Serial No.: 10/630,939 Filed: July 31, 2003

Amendments to the Drawings:

REMARKS

Fig.5B (PRIOR ART)

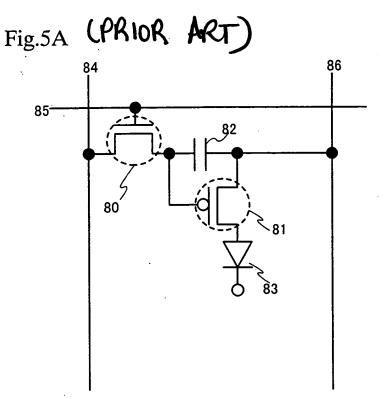
In Figs. 5A and 5B, the legend "Prior Art" has been added.

The drawings have been objected to because Figs. 5A and 5B do not include the legend "Prior Art." Applicant is submitting corrected drawings for Figs. 5A and 5B, and these corrected drawings include the legend "Prior Art," as suggested by the Examiner. Accordingly, applicant requests withdrawal of this objection.

The attached replacement sheet of drawings includes changes to Figs. 5A and 5B and replaces the original sheet including Figs. 5A and 5B.
